# THE GLIDING FEDERATION OF AUSTRALIA

## AIRWORTHINESS DIRECTIVE GLIDER/POWERED SAILPLANE.

GFA/AD 242

SUBJECT: Securing instrument panel cover.

Fig.1.

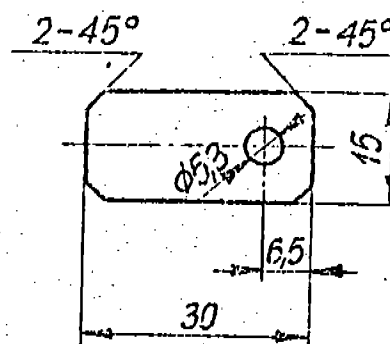
- (1) Make two plates to Fig. 1.
- (2) Fit plates as shown in Fig 2 bending up the legs to secure the cover under the head of the locating screw.

Make 2 plates  
from .5mm aluminium

Fig.2.

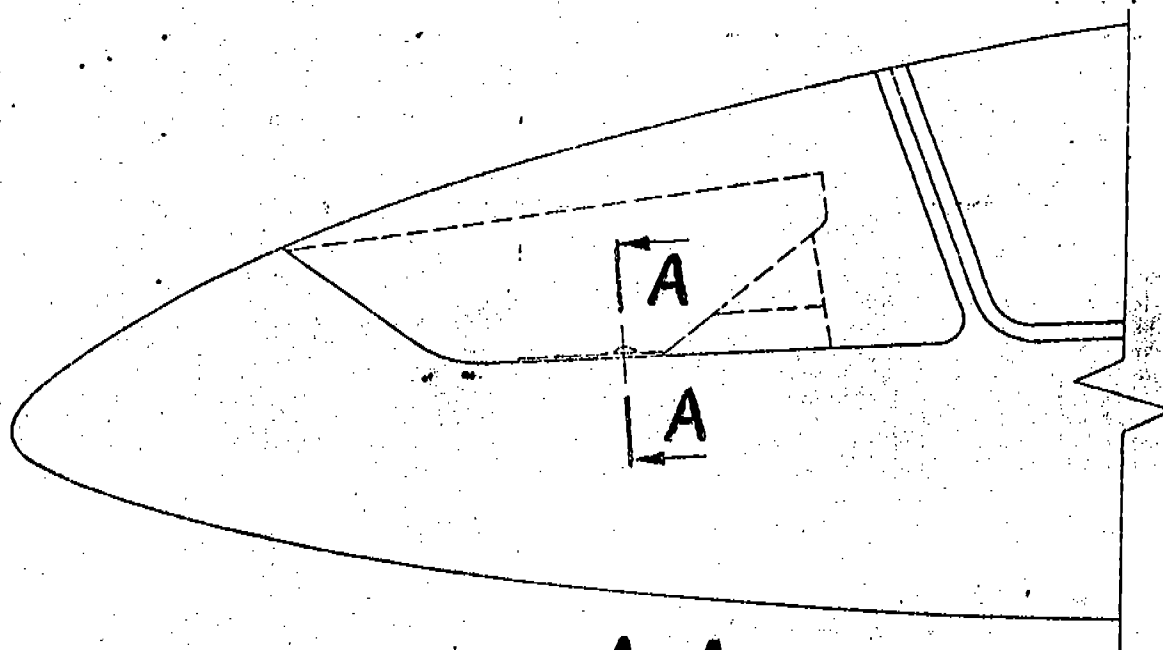
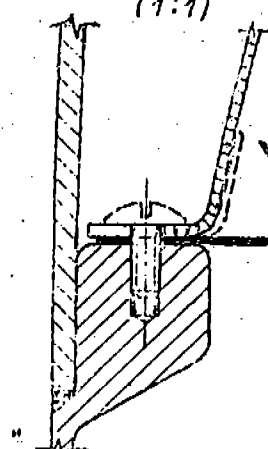
Bend up to fit and  
secure cover.
